Floyd Hill Design - Technical Team Meeting Summary

January 13, 2023, 9:00 AM to 12:00 PM

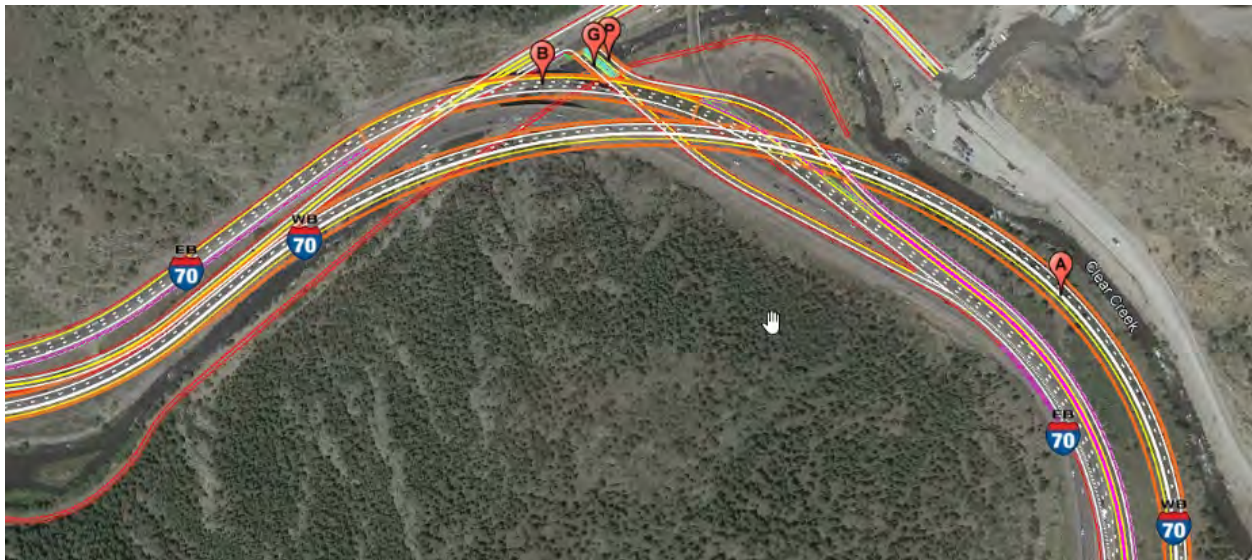
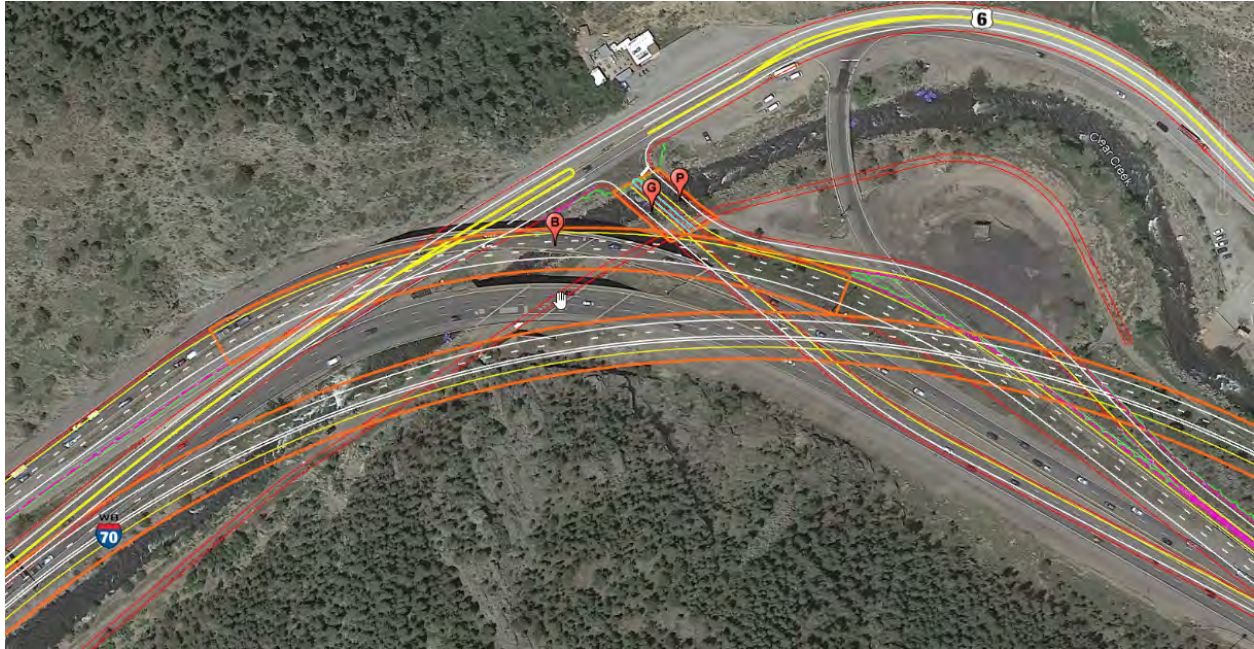
- **TT Question:** What is the plan for snow management on the off ramp, under the bridge? Will this area be icy?
- **Response:** Ideally, the underpass area will be protected from snow accumulation. Additionally, the slope of the roadway will guide snow off the right shoulder so it does not build up against the fixed barrier. Snow from WB mainline above will not be pushed onto the off-ramp. We will discuss snow removal at length when we discuss maintenance as we reach a recommendation.

- **TT Question:** What is the vertical clearance of the off ramp under the WB lane? Will this area remain shaded and accumulate ice?
- **Response:** The design team has been working on these details. So far, we have identified that the off ramp will have at least 16'6" clearance to meet FHWA requirements. We have not yet done a shade study so we cannot speak to where there will be shade.

- **TT Question:** Have you incorporated lighting into this planned area?
- **Response:** We have not yet discussed lighting, but an underpass like this would typically include underpass lighting.

- **TT Question:** What kind of deicing material will be used on the bridge? Will that contribute salinity to runoff?
- **Response:** We understand that ice management is a priority concern on this project so we are planning to bring a maintenance professional to join one of our upcoming TT meetings to discuss this issue in greater depth. Today we want to focus on the structural elements of these options; maintenance factors will be discussed in the future.

Bridge B, Option 1:

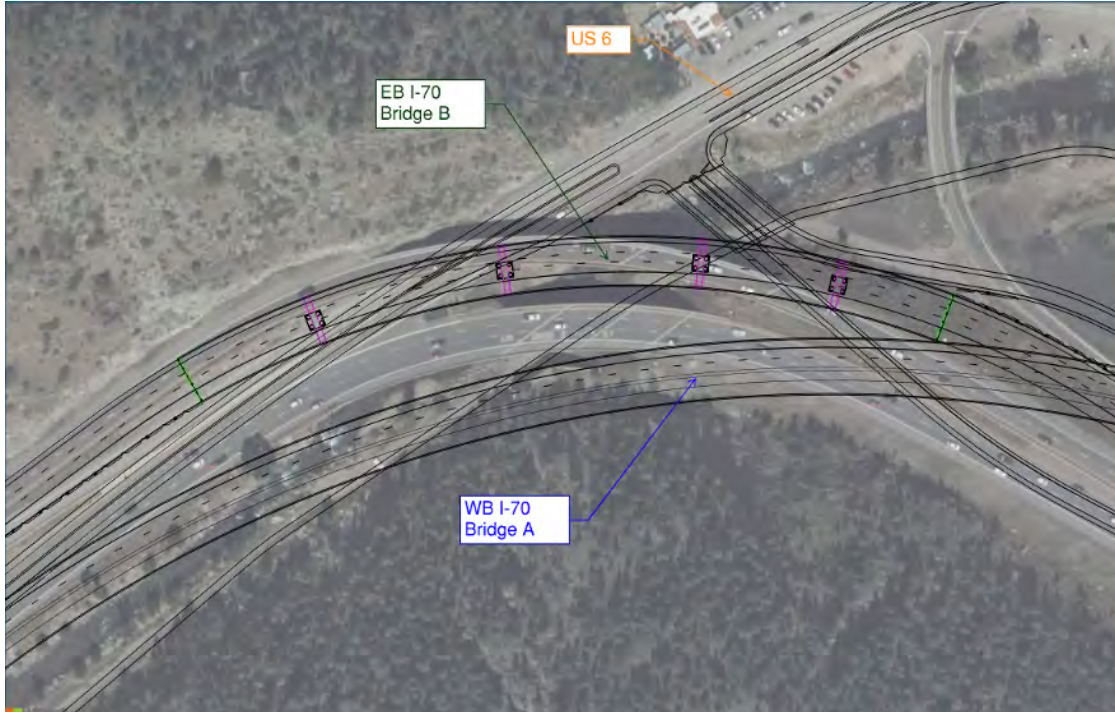
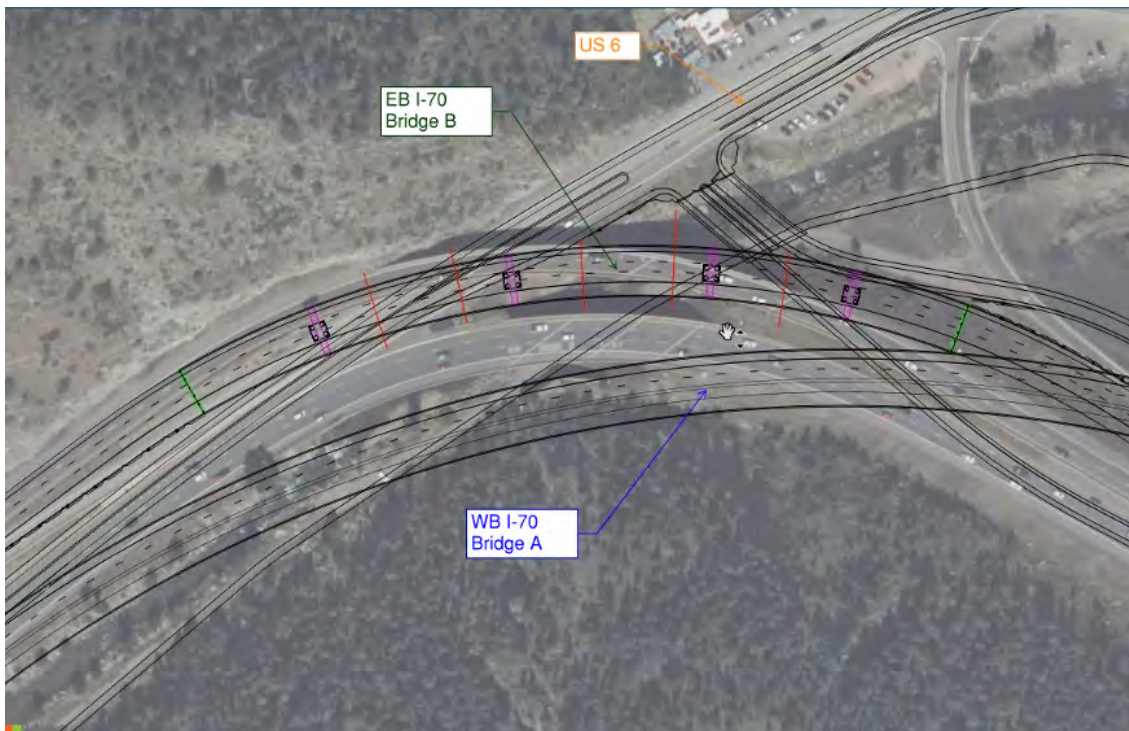
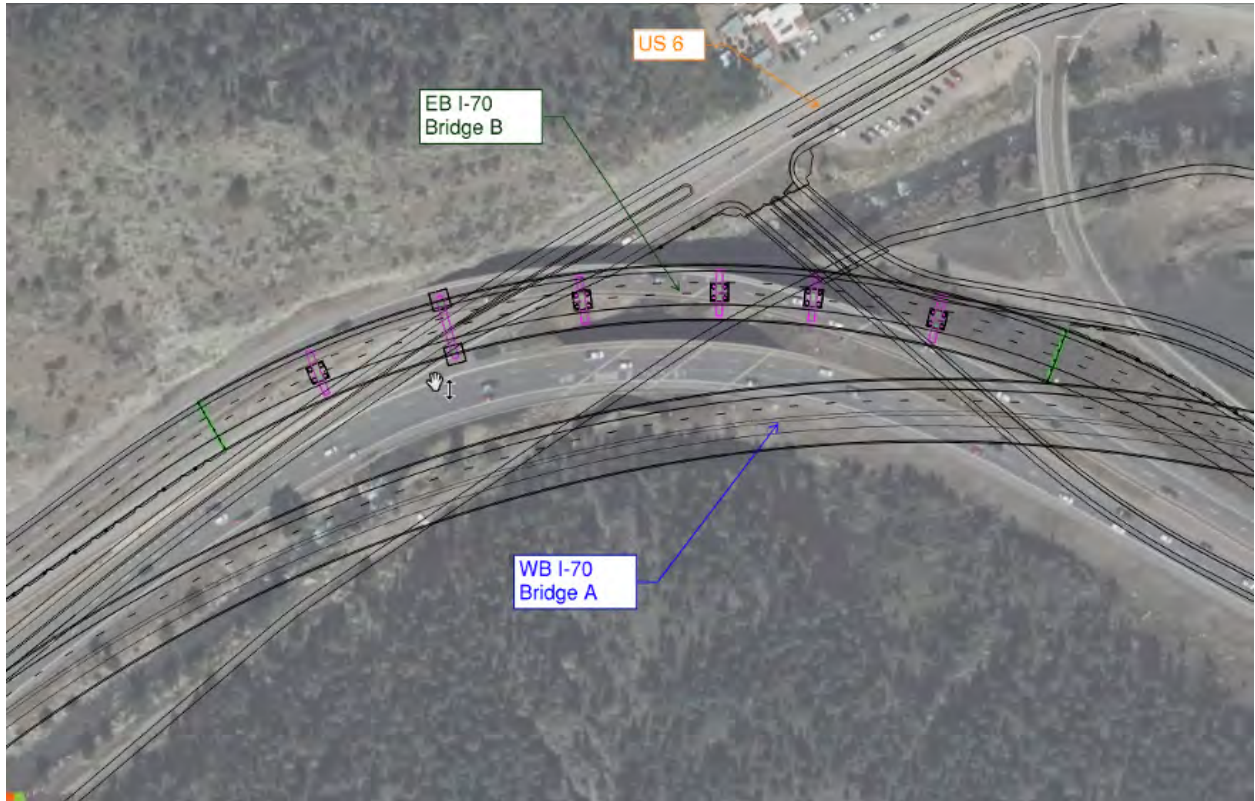
- **TT Question:** Does either option impact the creek to a greater extent?
- **Response:** Option 2 has shorter spans and will not require temporary supports, which reduces impacts to the creek.

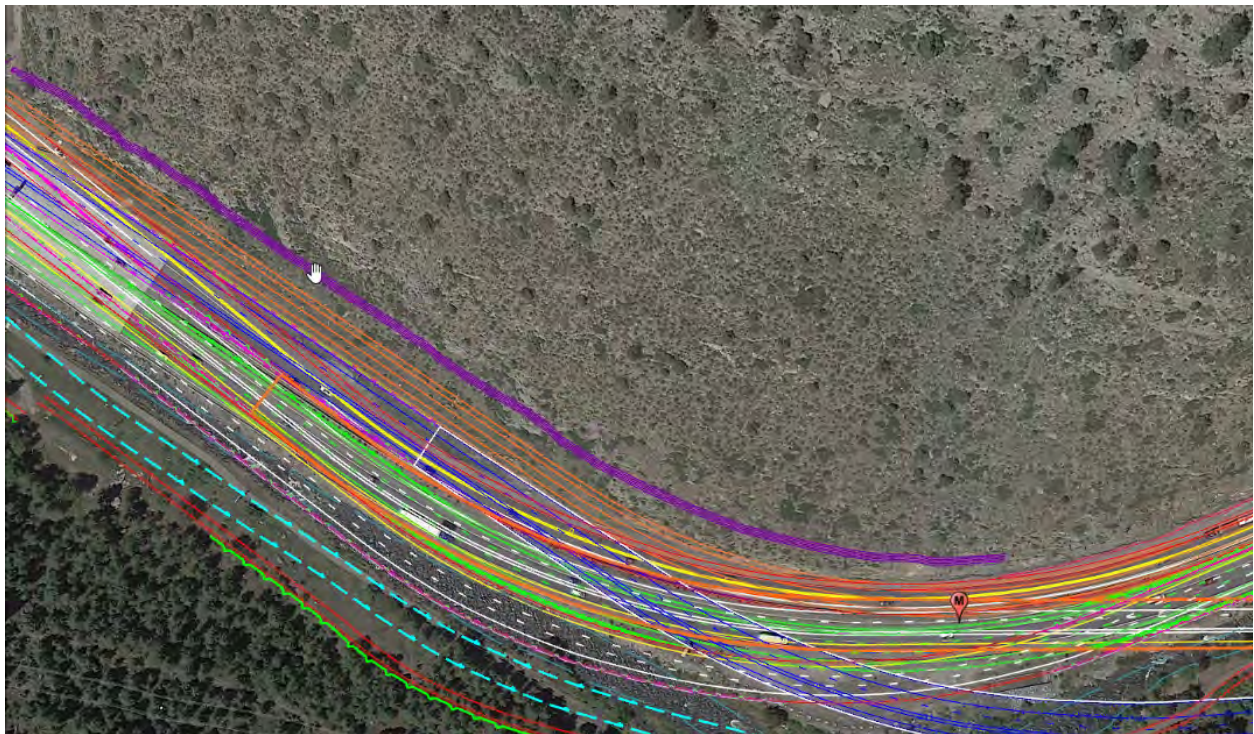
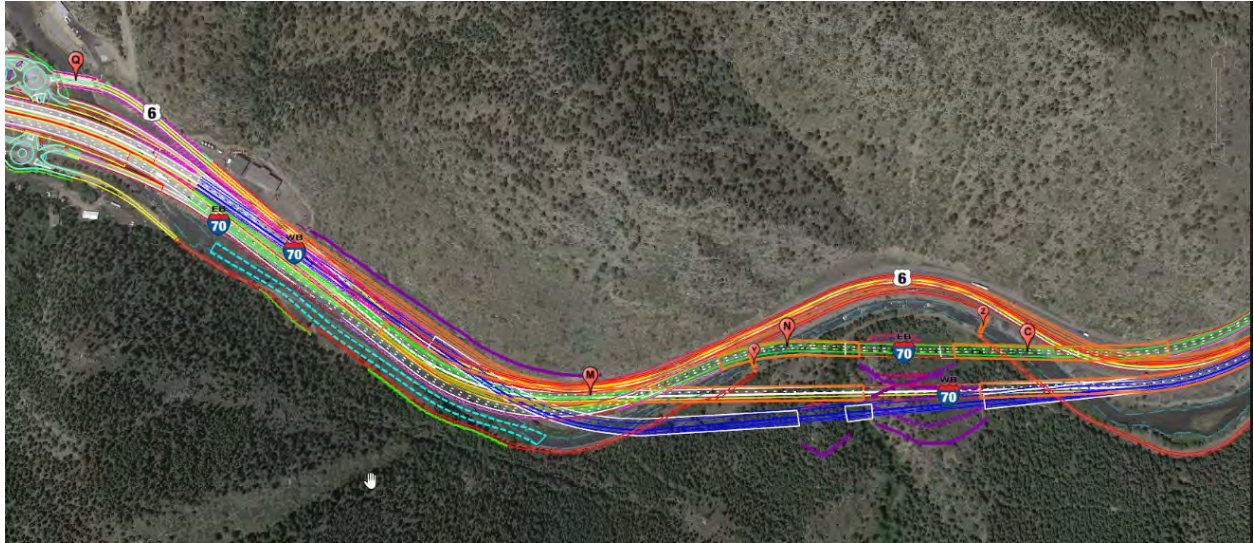
TT Question: How does this impact the FONSI?

Response: If the design team moves forward with the realignment, it will require an environmental reevaluation to be incorporated into the FONSI. The team will need to develop the design further for this to occur.

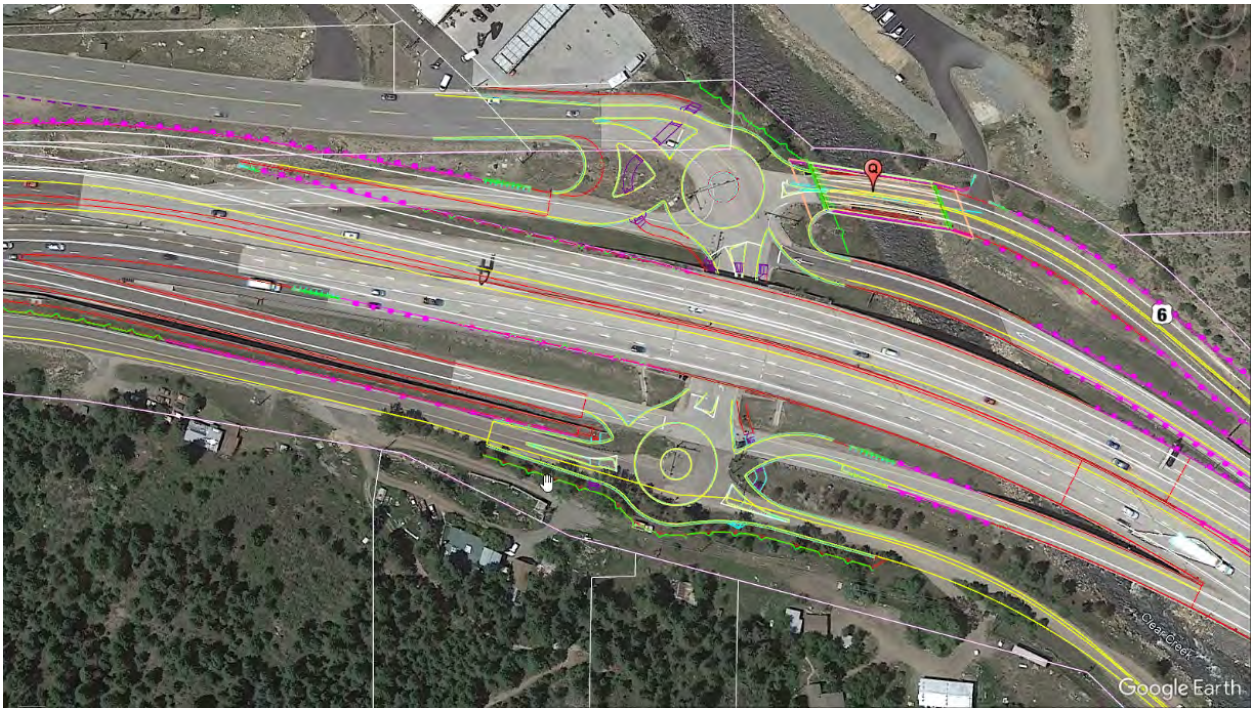
- **TT Question:** Did the model you used project out to anticipate traffic volumes or is it based on current traffic volumes?
- **Response:** The model projected out and was based on 2045 traffic volumes.

- **TT Question:** Does the intersection option incorporate other improvements?
- **Response:** The alternative to constructing roundabouts would be no improvements beyond the existing signalized intersections. There would be improvements to the I-70 mainline, on ramps, and off ramps, as well as an improved bridge Q (as seen in the image above). However, all walls along the roadway and greenway trail would go away indicating fewer impacts to this area.

- **TT Question:** How would signaling work at both intersections with multiple lanes coming in (as seen in the image above)?
- **Response:** The signal can be adjusted to give priority to the higher volume intersection.
- **Comment:** Cyclists will likely go through that red light because signals cued by volume do not pick up on cyclists.
- **Response:** There are technologies we can incorporate to ensure cyclists have a way to cue the light.
- **Comment:** A consideration is consistency along this corridor: there are roundabouts before and after this intersection area. However, I do see the benefits of no constructing roundabouts at this interchange.

- **TT Question:** Does this model take into account no WB On ramp at the US 6 Interchange?
- **Response:** Yes.

- **TT Comment:** One additional consideration is how the traffic volumes and use in this area vary from winter to summer. In the winter, most drivers are passing through whereas during the summer, recreationalists will get off and park in this area to access the creek. Could that impact the modeling?
- **Response:** We did not run the model based on seasonal differences, which could be something to look at to ensure there are not any large differences.

ACTION: Design Team to run model based on summer vs. winter traffic.
